BHP Mitsubishi Alliance

Appendix J

Request for Information Response

**Caval Ridge Mine: Horse Pit Extension Project
 Request for Information Addendum**

Figure 2-1 Indicative Mining Schedule Outputs (ROM t and Product Coal t)

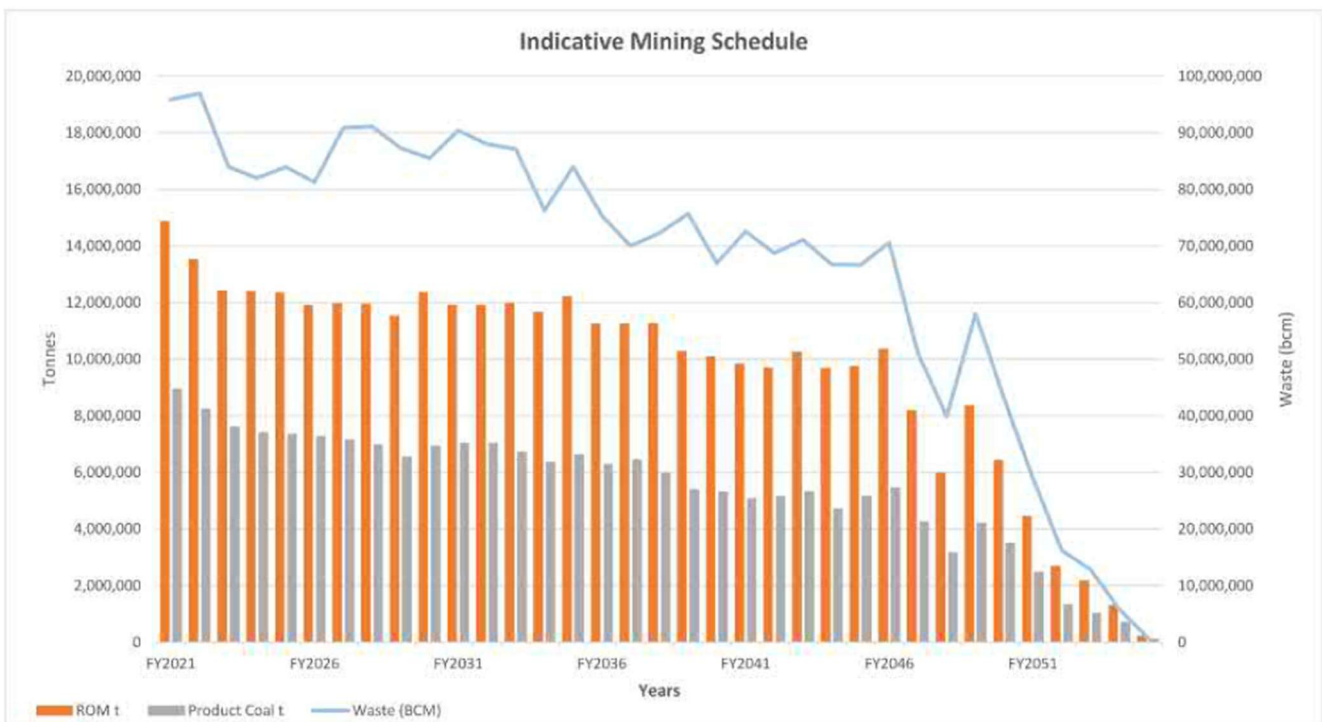
The annual run-of-mine (ROM) coal to be extracted from the CVM will vary each year depending on a variety of factors. The maximum per annum ROM coal however will be 15 Mtpa, with an average of 12.5 Mtpa over the life of mine (LOM).

Figure 3-6 of the EA Amendment Supporting Documentation (and replicated as Figure 2-1 below) shows the indicative mining schedule outputs featuring indicative annual ROM coal tonnage and Product coal tonnage. The figure has been replicated below for completeness. Mine scheduling indicates output of ROM coal of almost 15 Mtpa in FY2021 with a trending decrease in output as mining progresses to closure.

Figure 3-1 Horse Pit Extension

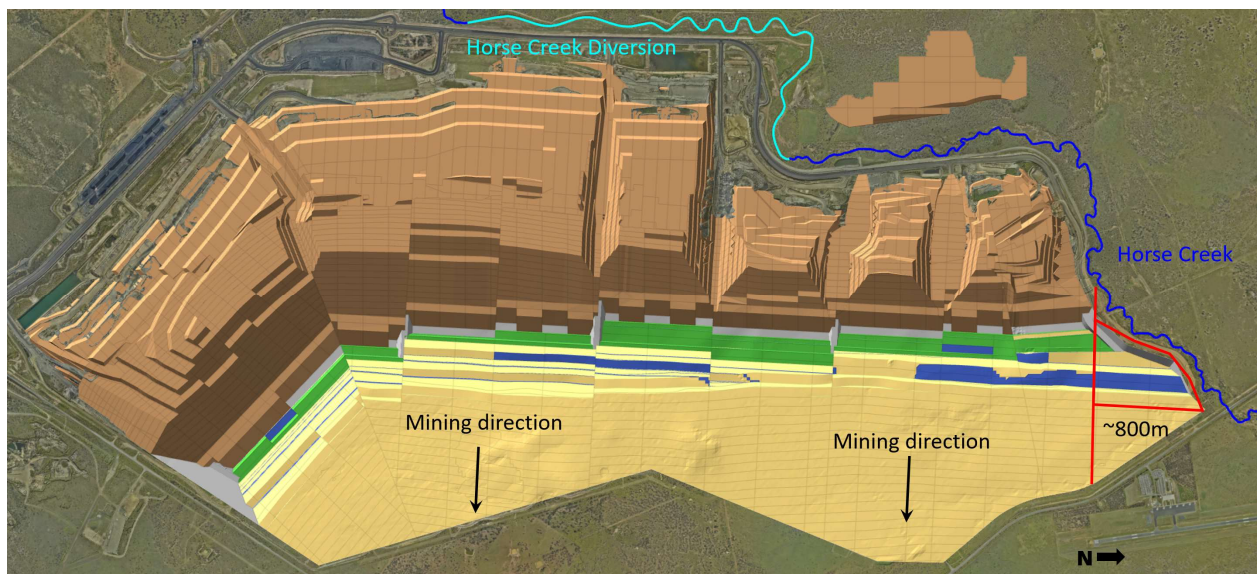
Requested Action 4: Provide further details of why an out of pit dump is a required option, if proposed.

An OOPD is proposed in order to provide the dump capacity required to mine the Project.

The Project (Figure 3-1) will continue mining to the east and is earmarked to commence in 2032 (as per current schedules). The northern most component of Horse Pit extends by ~800m (highlighted in Figure 3-2 below) and is limited to within a distance of Horse Creek. In a lead up to start of extension (2032) until the end of mine life, this northern extent is associated with a substantial increase in mining intensity. This is due to progressive closure of Heyford Pit at this time and due to the southern end of Horse Pit being already at capacity at that point in time. This places significant pressure on spoil balance and supports requirement of an OOPD on top of other dumping options already in place.

Standard mining practice includes allowance for ~ 25% buffer for dump capacity. The proposed approach described above, steadily decreases the available dump room down to ~2% of cumulative dig volumes.

Figure 4-1 Set-back to FoS \geq 1.5

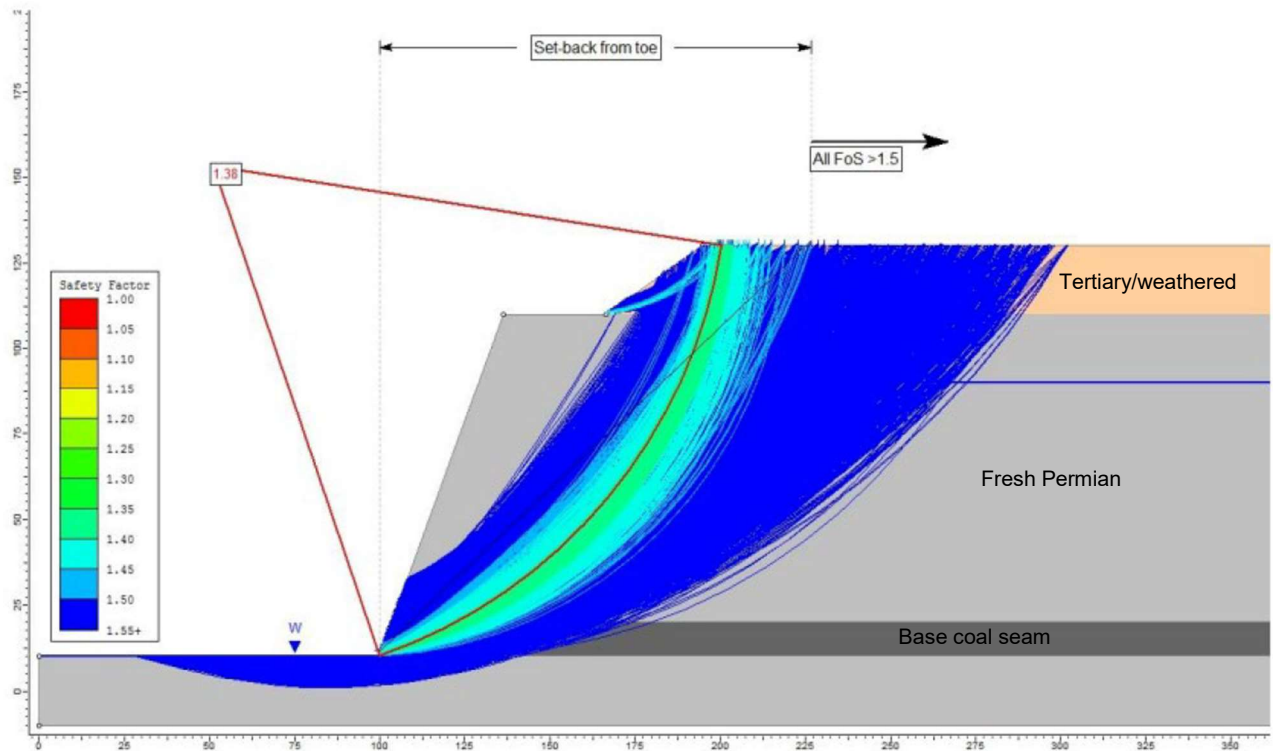
Requested Action 5: Given the close proximity of the proposed highwall to the Peak Downs Highway and the Moranbah Access Road as well as to the township of Moranbah, provide a geotechnical report of the final design of the highwall which includes the following:

Limit equilibrium has been used to geotechnically assess the highwall of Horse Pit. Limit equilibrium is currently accepted by industry as the most practical method available. It compares forces on a surface with (limiting) strength if it was at the point of failing. Defects may be included explicitly as discrete strata when known, but more often are implicit within the strengths of broader material layers.

The final void is designed with the required highwall set-back to achieve a minimum factor of safety (FoS) of 1.5 at the mining lease, the Peak Downs Highway corridor and the Moranbah Access Road corridor. This is illustrated in Figure 4-1. This figure is simplified to show the overall wall angles within the Tertiary, weathered Permian and fresh Permian material. A minimum FoS of 1.5 is generally adopted for long-term stability of civil engineering features which have broad public access, such as road cuttings and dam walls.

Figure 10-4 HPE Monitoring Network

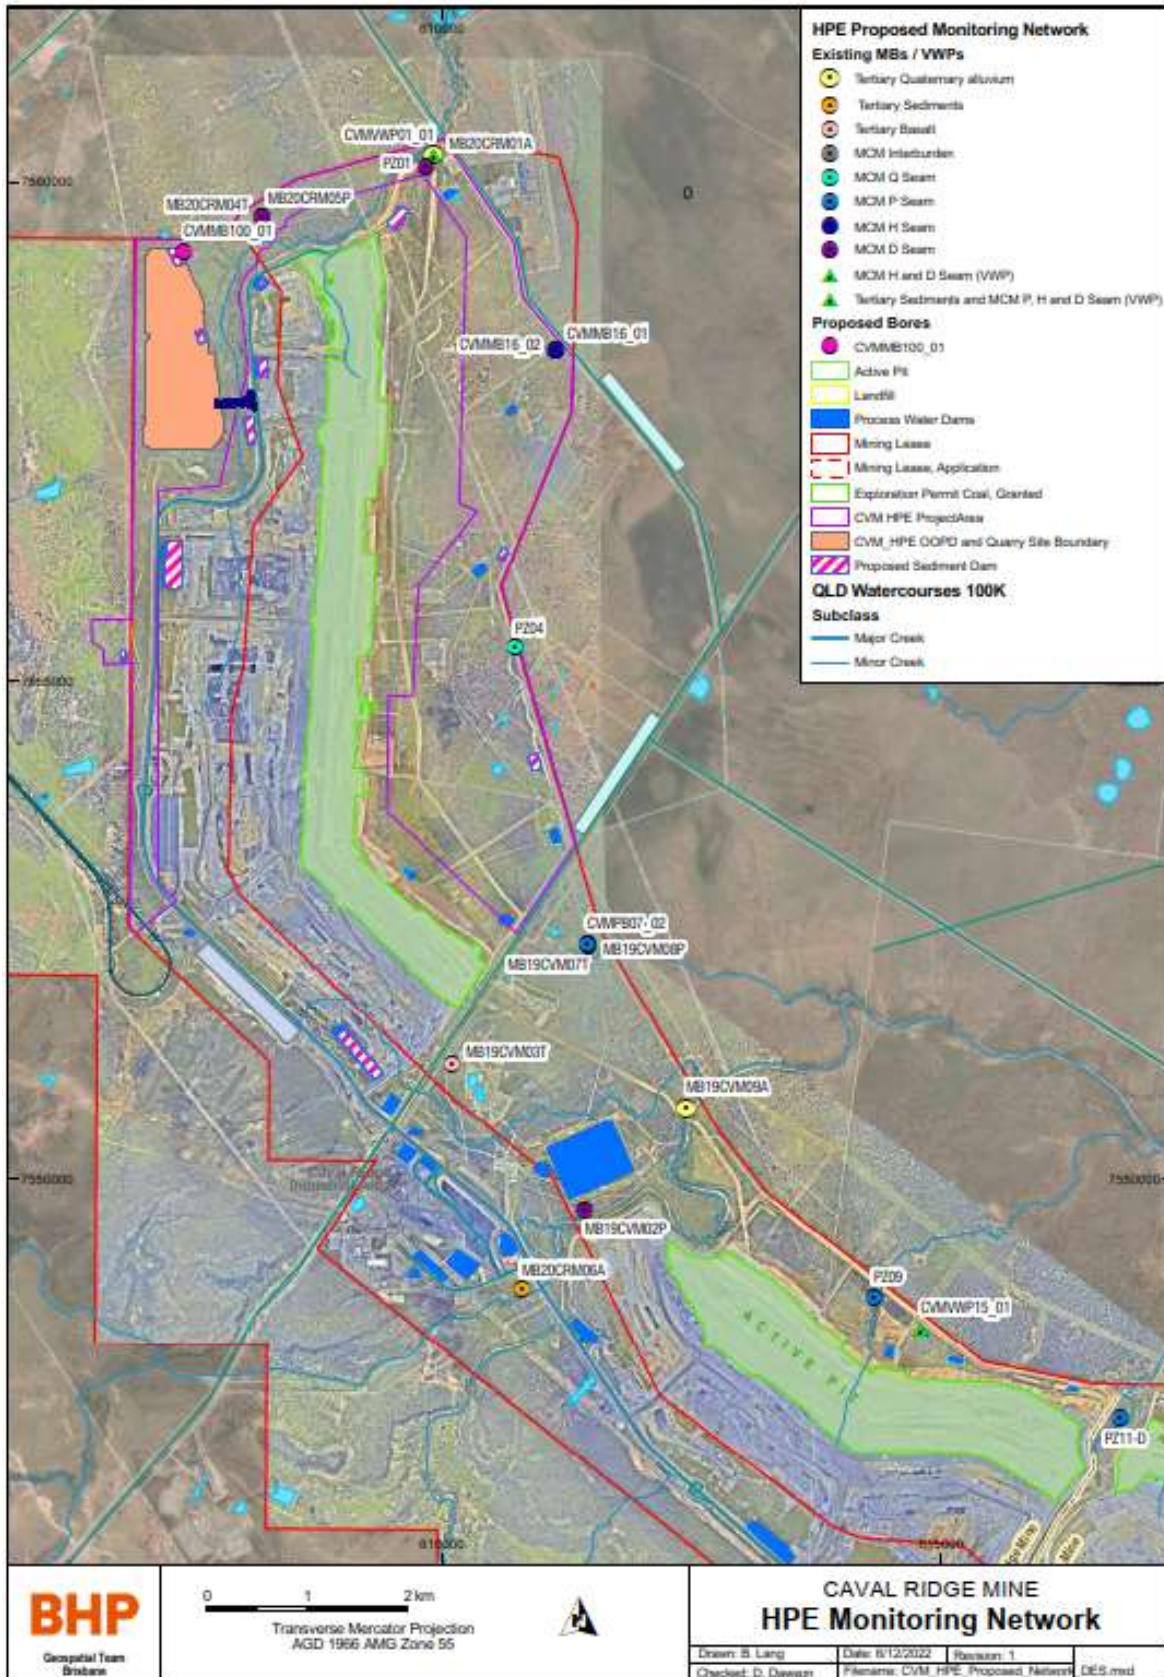
Figure 8-1 of Appendix F indicates that the groundwater monitoring bores of the proposed monitoring network are within the pit extent of the extension project. Additionally, there is a lack of bores on the western side of the mine for identification of upgradient concentrations.

The following section describes the monitoring infrastructure proposed to monitor predicted Project impacts. 19 monitoring bores (18 existing and 1 proposed) and two (2) VWP sensor arrays have been nominated in up and downgradient locations across the Project Area. Proposed monitoring infrastructure detail and rationale are presented in Table 10-3 with locations displayed in Figure 10-4.
